ENGINEERING CHANGE NOTICE

1. ECN 666067

6. Project Title/No./Work Order No.	7. Bldg./Sys./Fac. No.	8. Approval Designator	
		Interim Stabilization, Essential Drawings, 113340	241-G/200-GEN	N/A

RPP-7567, REPORT ON NEW PUMPING SYSTEM SOFTWARE ON PUMPING
INSTRUMENTATION AND CONTROL SKIDS

LAD 5 - --- Total Rungs in File = 83

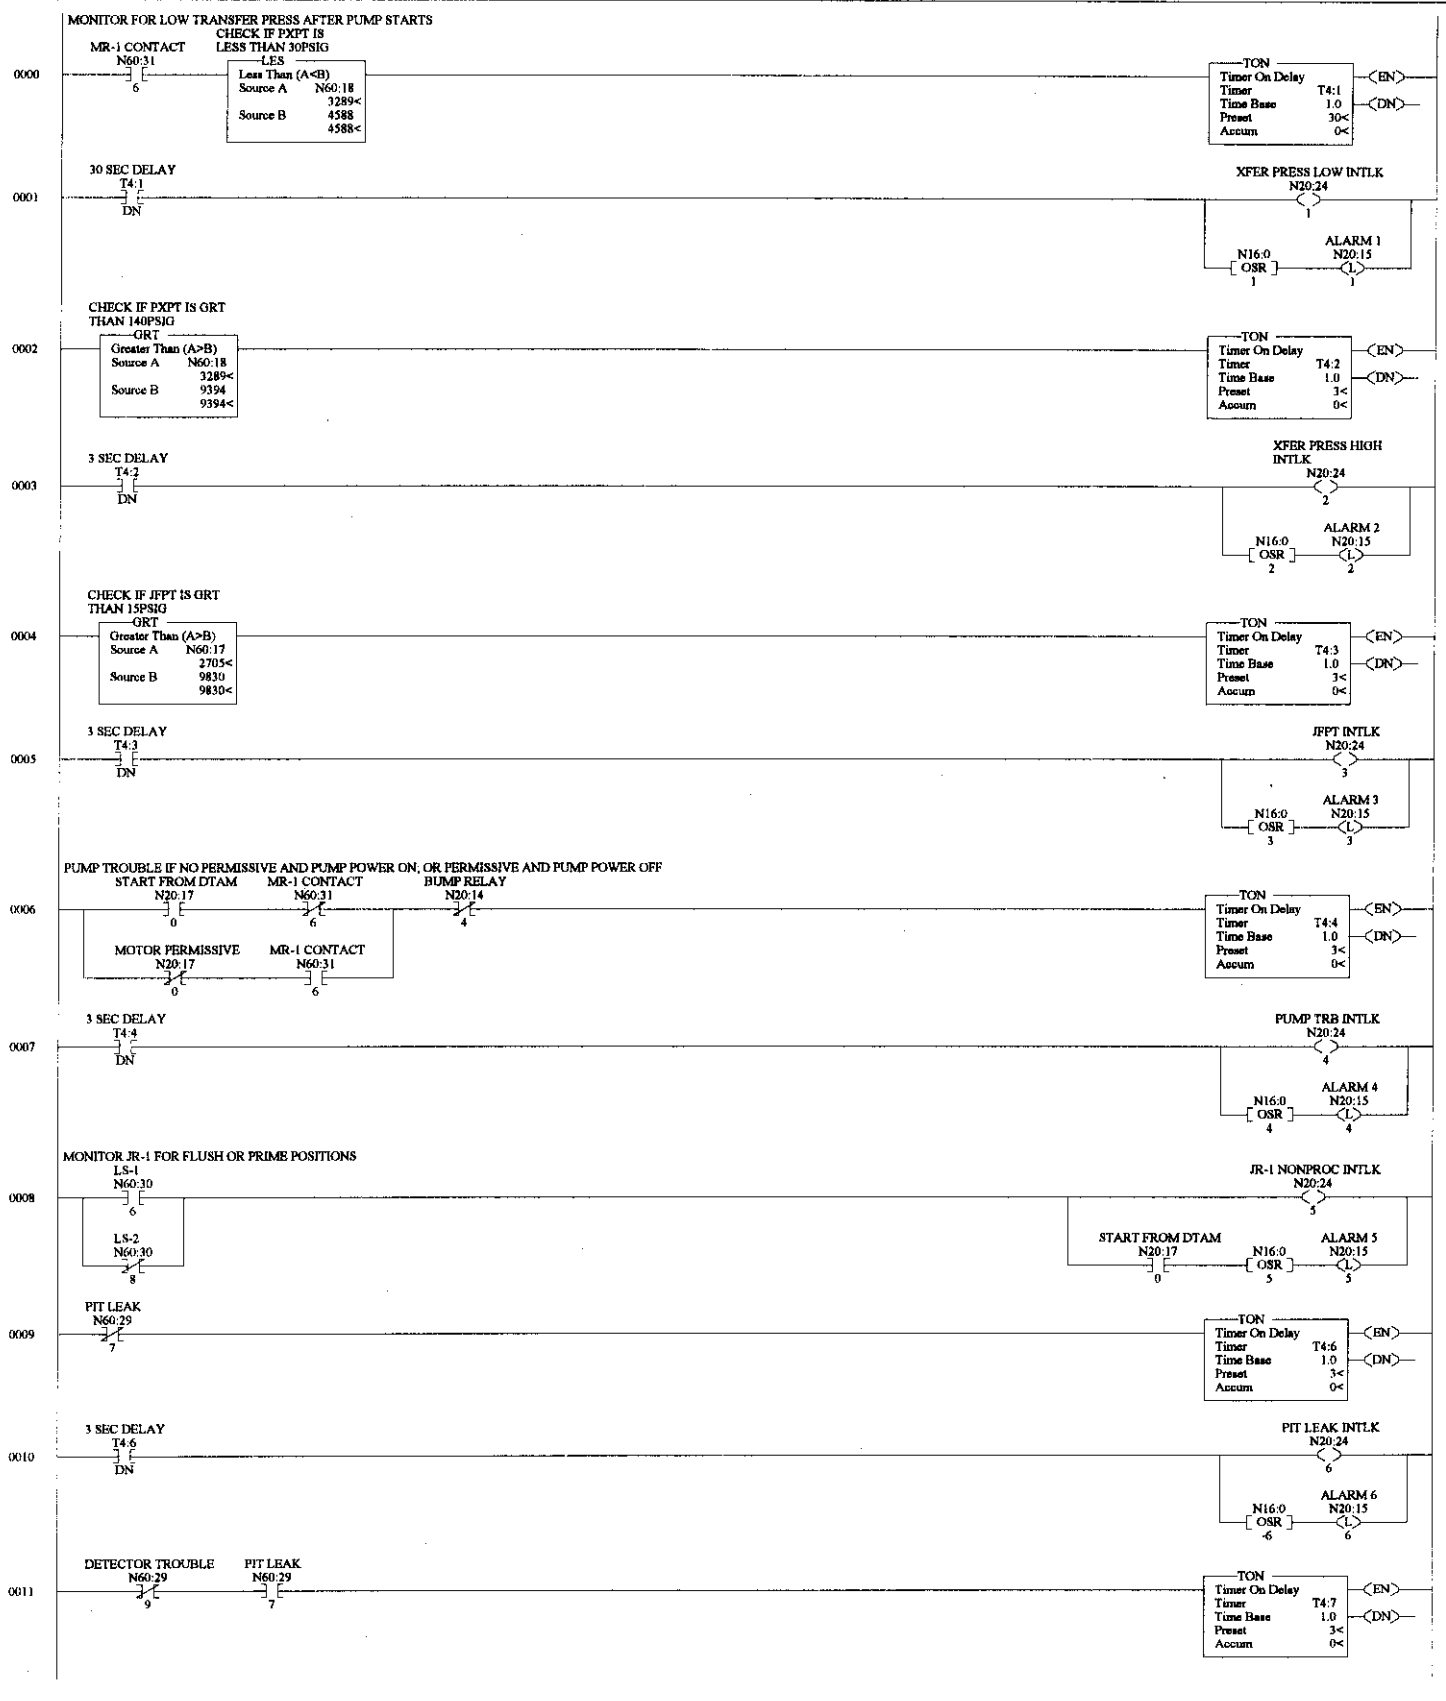
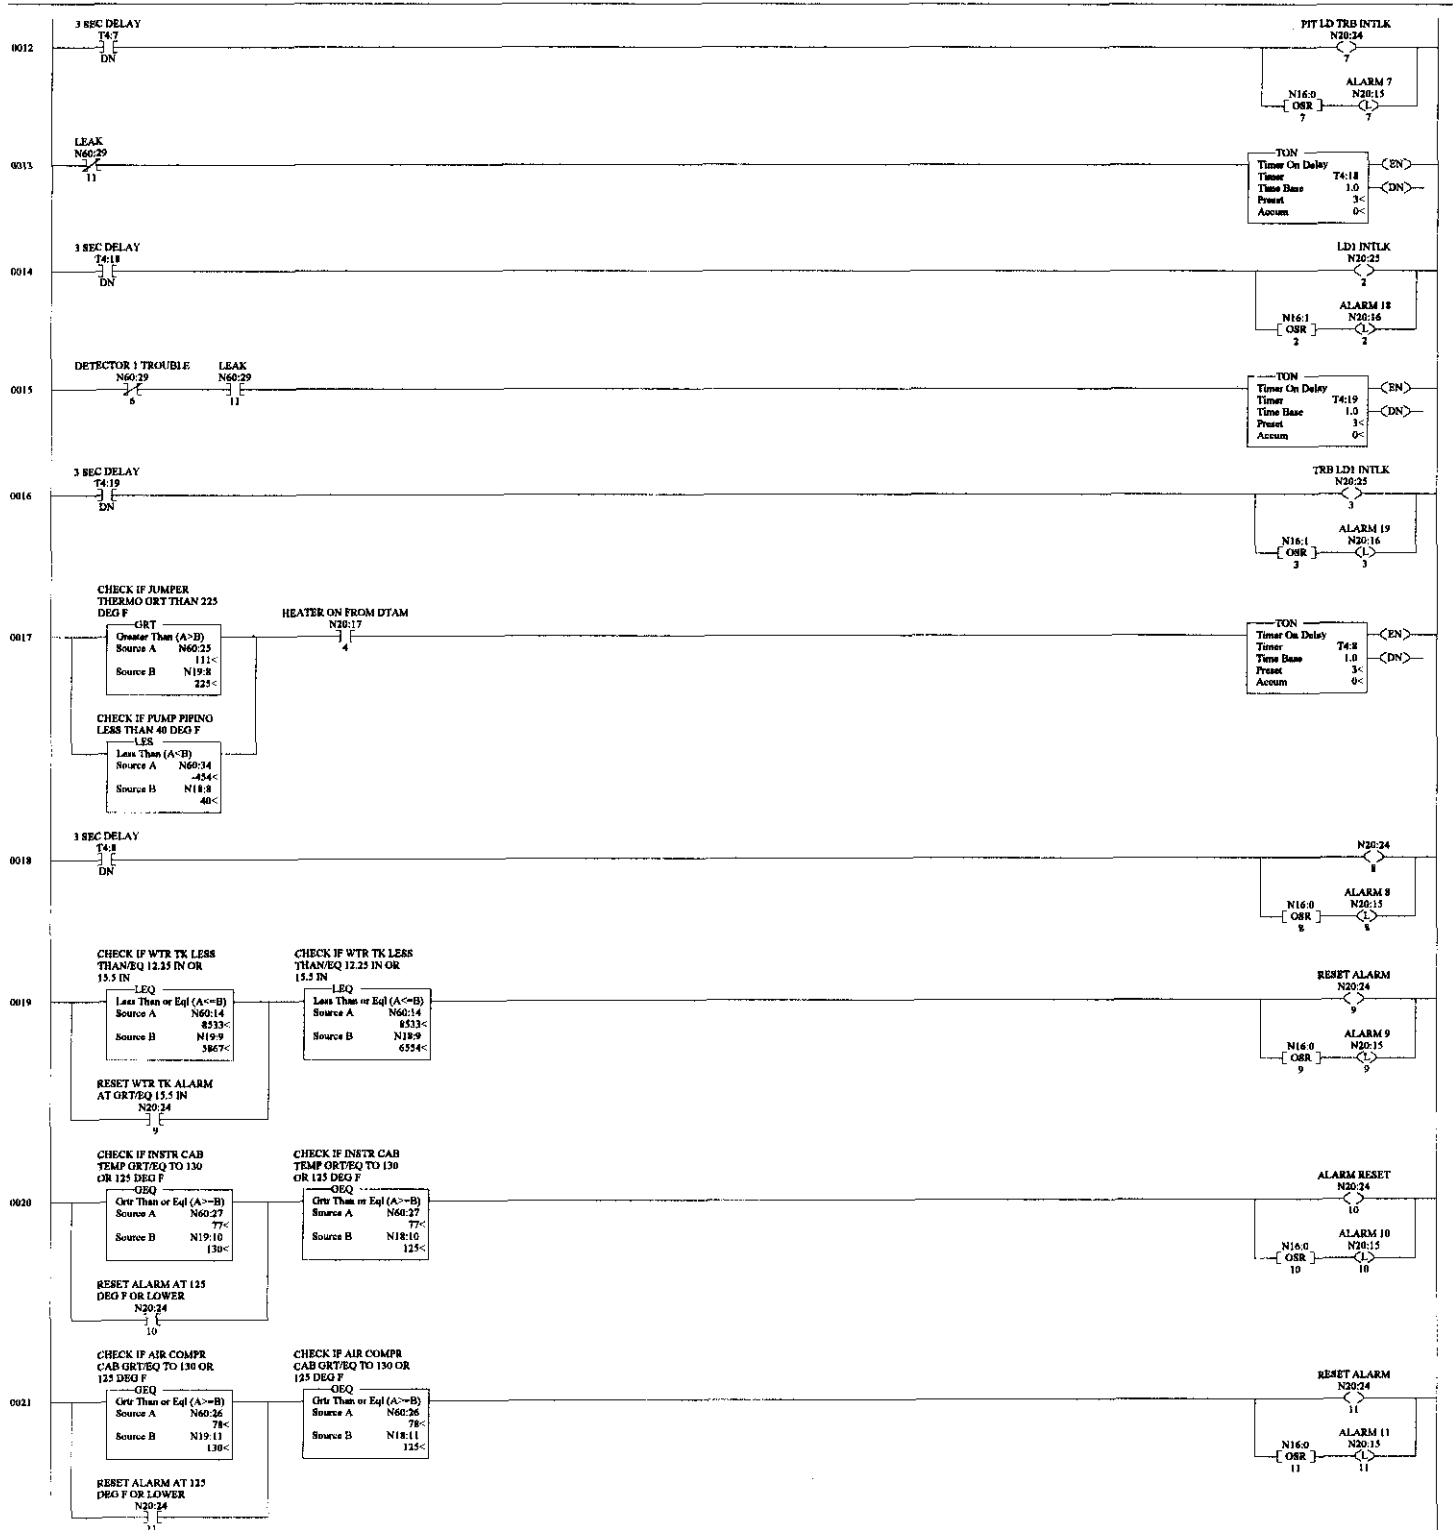
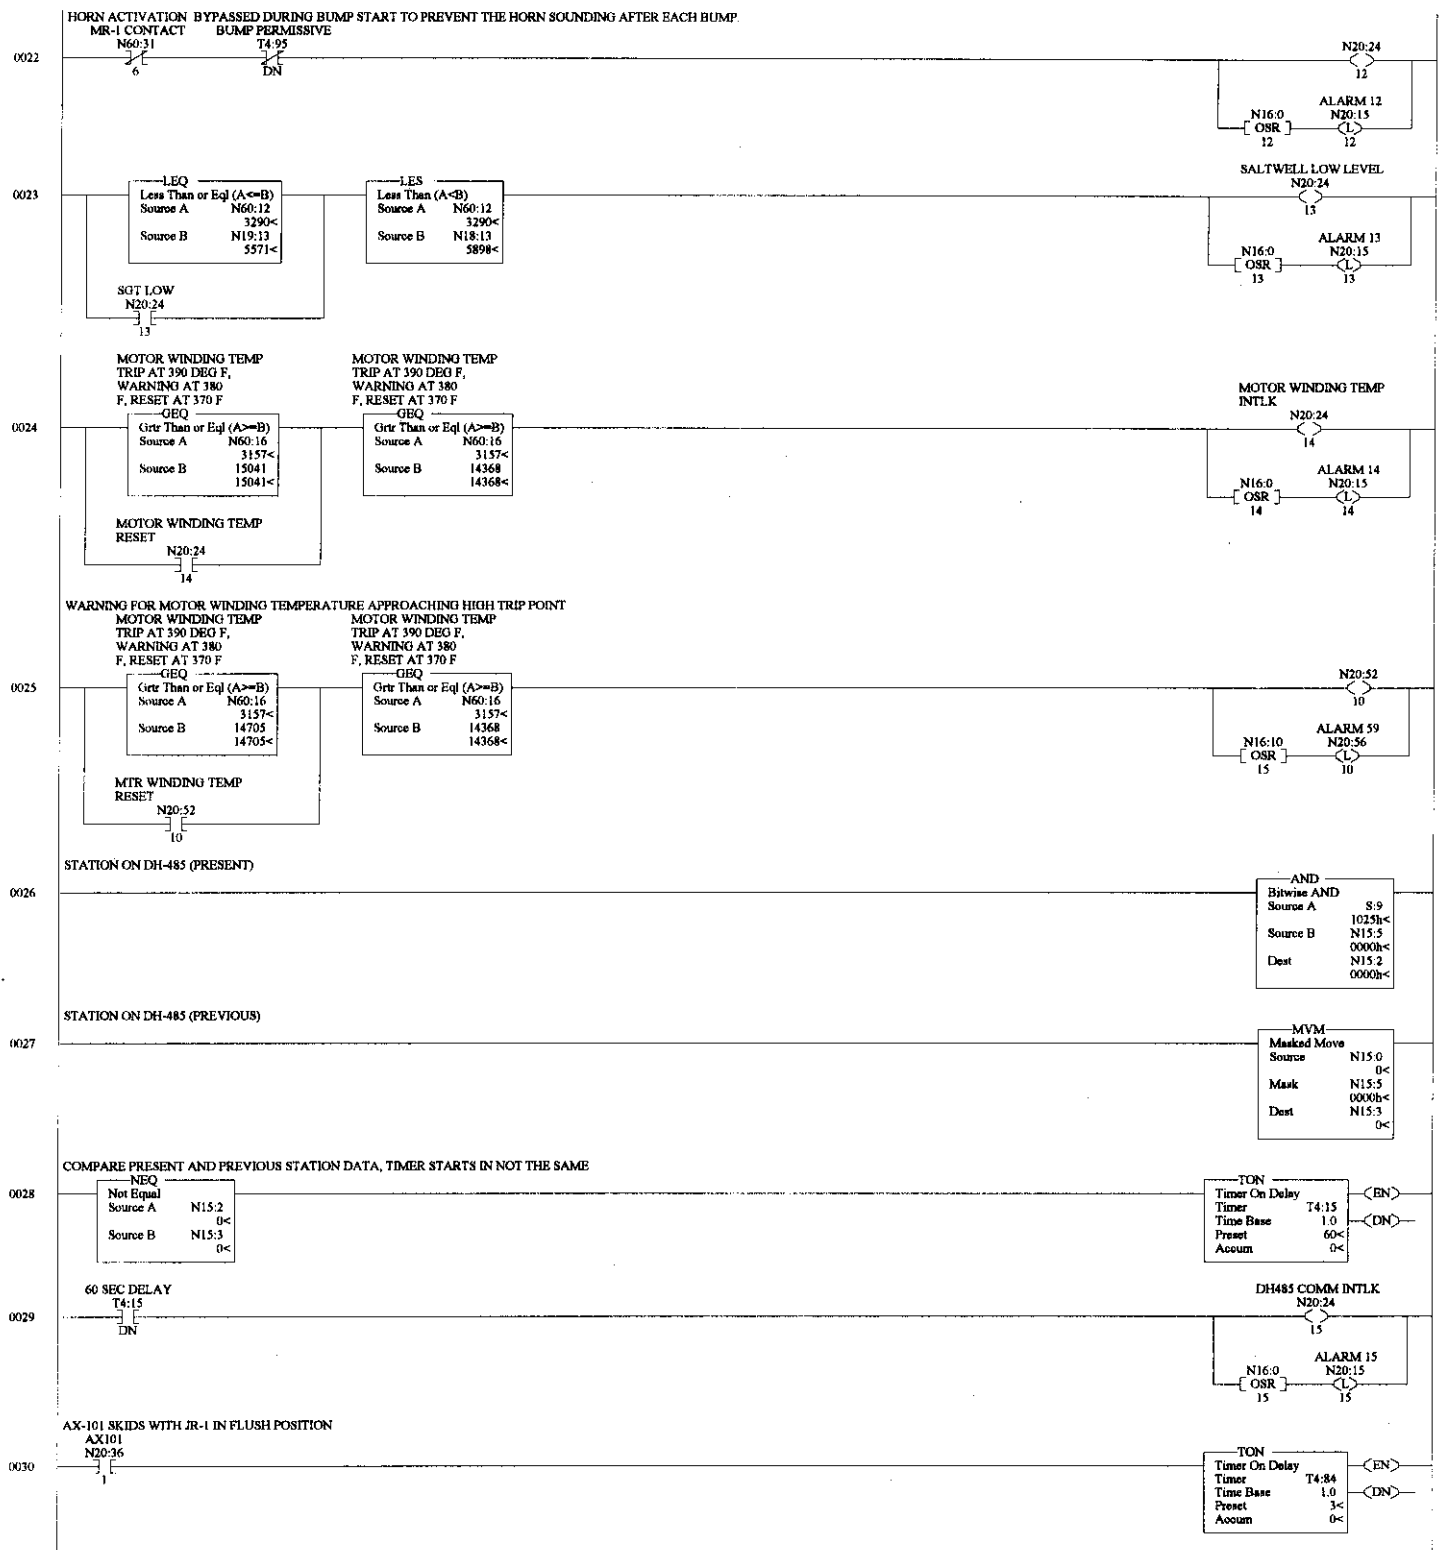
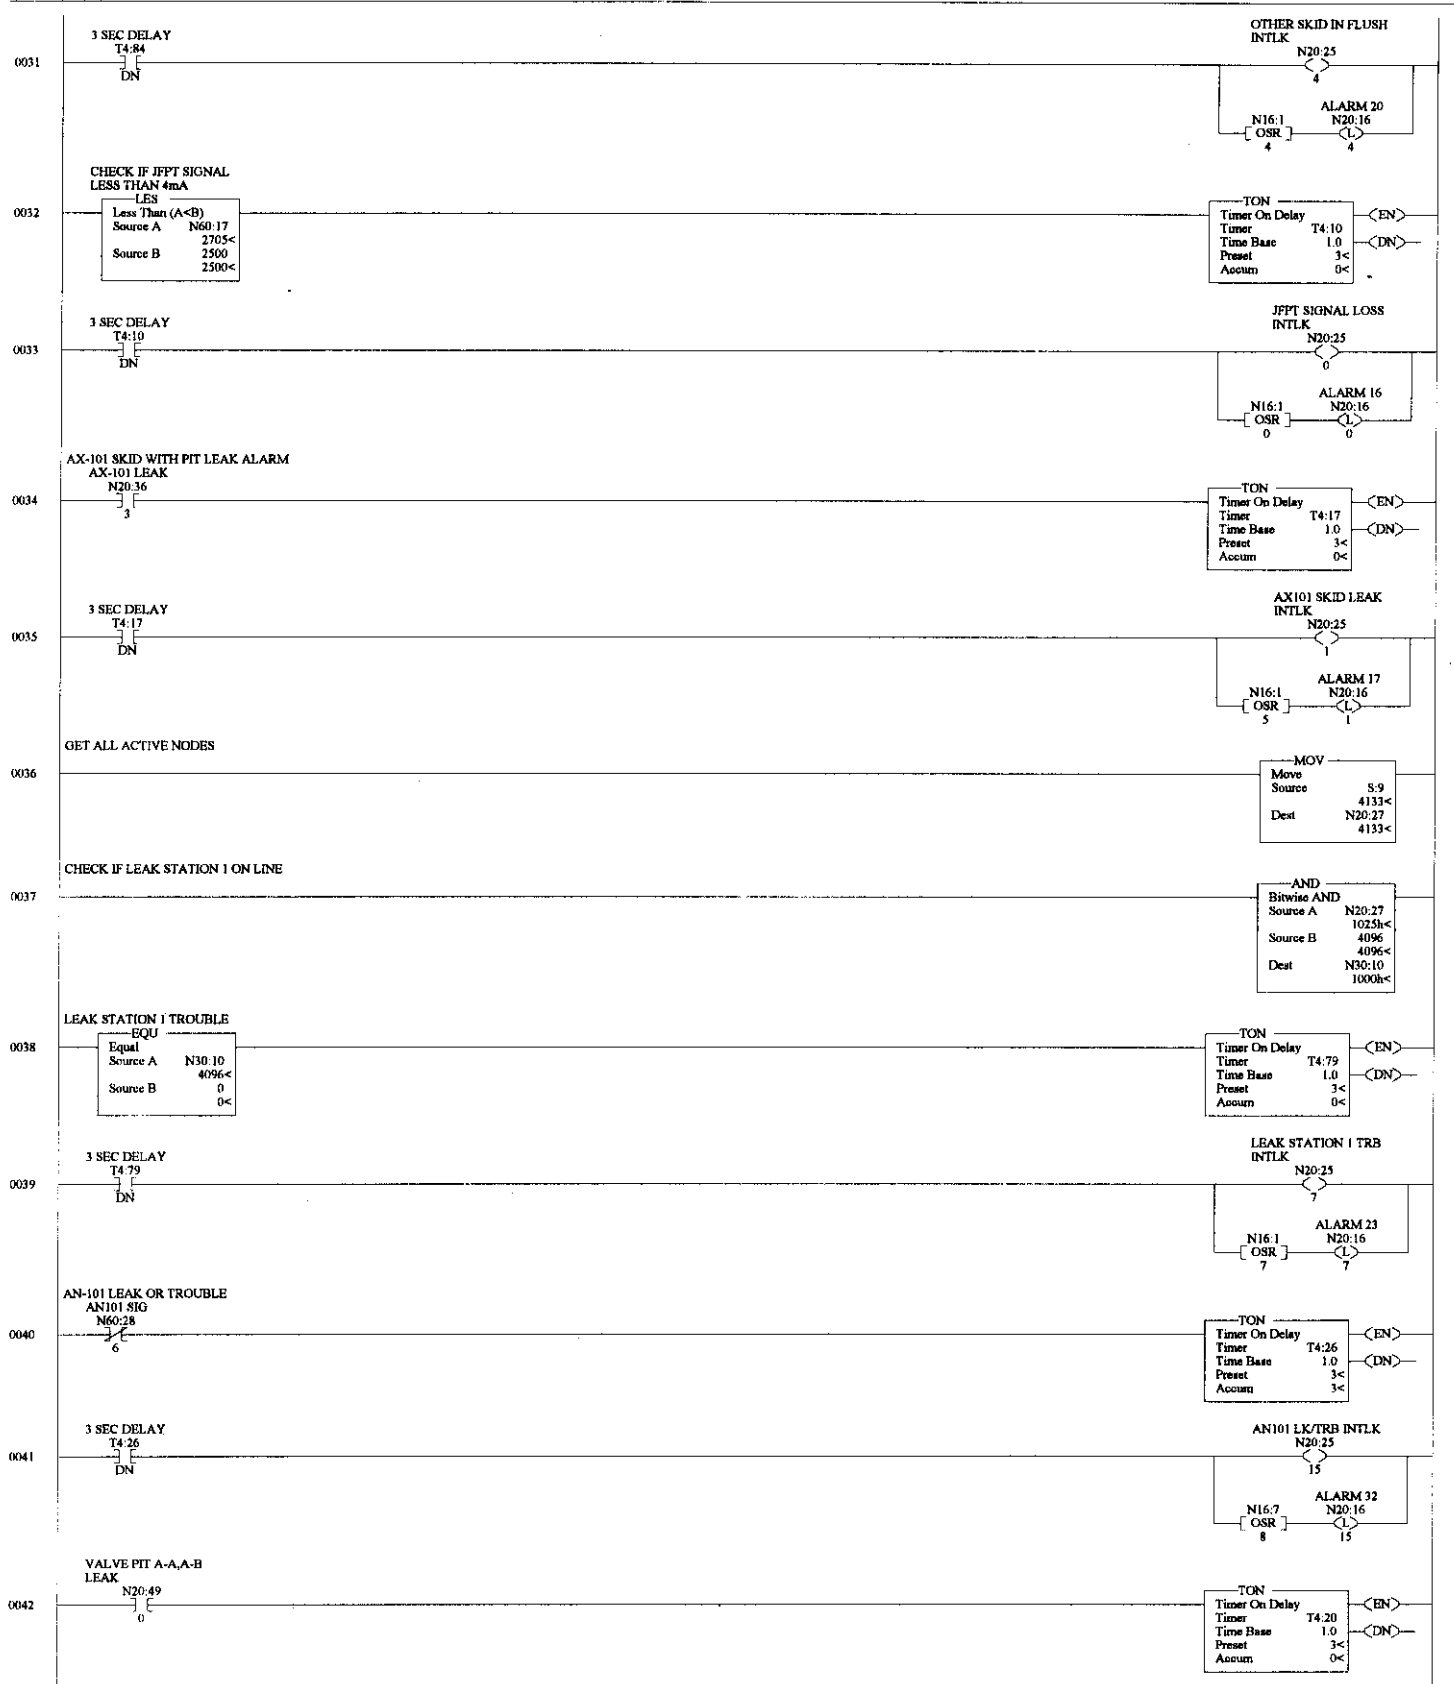
- 6.5 Ladder 5: This ladder is the alarm activation and interlocks for the saltwell pump motor. The following changes were made.
 - 6.5.1 The trip point in rung 0 is changed from 15 psig to 30 psig. This is due to the additional pressure from the injection water pump attached to the system.

- 6.5.2 Rung 6 has a bump relay contact added that is **TRUE** when the bump sequence is not active or during the bump sequence when the pump is running for the 1 second time period. The contact is **FALSE** during the 10-second shut-off time during the bump sequence to prevent a pump trouble alarm and interlock break from occurring.

- 6.5.3 Rung 17 has the pump low temperature logic portion is changed from the pump bearing thermocouple to the pump assembly thermocouple since the pump bearing temperature no longer exists. Alarm 8 will now activate upon jumper heat trace high temperature or low pump piping temperature.

- 6.5.4 Rung 22 has a bump permissive contact inserted that is **TRUE** when the bump sequence is inactive. The contact is **FALSE** when the bump sequence is active to prevent the shutdown alarm and horn during the 10 second off time during the bump sequence. A time delay contact is used to prevent a false alarm during the switch from bump to normal start.

- 6.5.5 Rungs 24 and 25 are deleted since the recirculation pressure transducer no longer exists. Two new rungs 24 and 25 are inserted for the motor winding temperature high shutdown and warning. Rung 24 monitors the winding temperature and will break the interlock and activate alarm 14 when the temperature is 390 degrees F or higher. The interlock will remake and alarm clear upon the temperature dropping below 370 degrees F. The logic functions as follows: when the temperature is 390 degrees F or higher, the two GEQ become **TRUE** thus making the interlock and alarm outputs **TRUE**. The reset contact N20:52/10 becomes **TRUE**. When the temperature drops below 390 degrees, the first GEQ becomes **FALSE**, but the rung remains **TRUE** due to the reset contact. When the temperature drops below 370 degrees, then the second GEQ becomes **FALSE**, thus making the alarm, interlock and reset elements in the rung **FALSE**. New rung 25 functions in the same manner except the true setting is at 380 degrees F, but the reset point is the same at 370 degrees. There is no interlock associated with rung 25, only alarm 59. This rung is to provide a warning to the operator that the motor temperature is approaching the high shutdown temperature.

- 6.5.6 Rungs 56 through 57 are deleted. The recirculation pressure and signal loss are no longer used. The motor bearing temperature is replaced with the motor winding high temperature in new rungs 24 and 25 described above. A new rung 56 is added for the power monitor interlock and alarm. The series high and low power contacts on the power monitor are monitored by address N60:31/8. When either of the power monitor contacts open, the N60:31/8 contact in rung 56 becomes **TRUE**. If the pump motor is running, then when the power monitor contact is true, the interlock and alarm outputs become **TRUE** thus breaking the motor interlock and activating alarm 40. The power monitor has internal circuitry for delays for startup power changes. The interlock and alarm clear upon pump shutdown due to both the motor and power monitor contacts resetting making the rung **FALSE**.
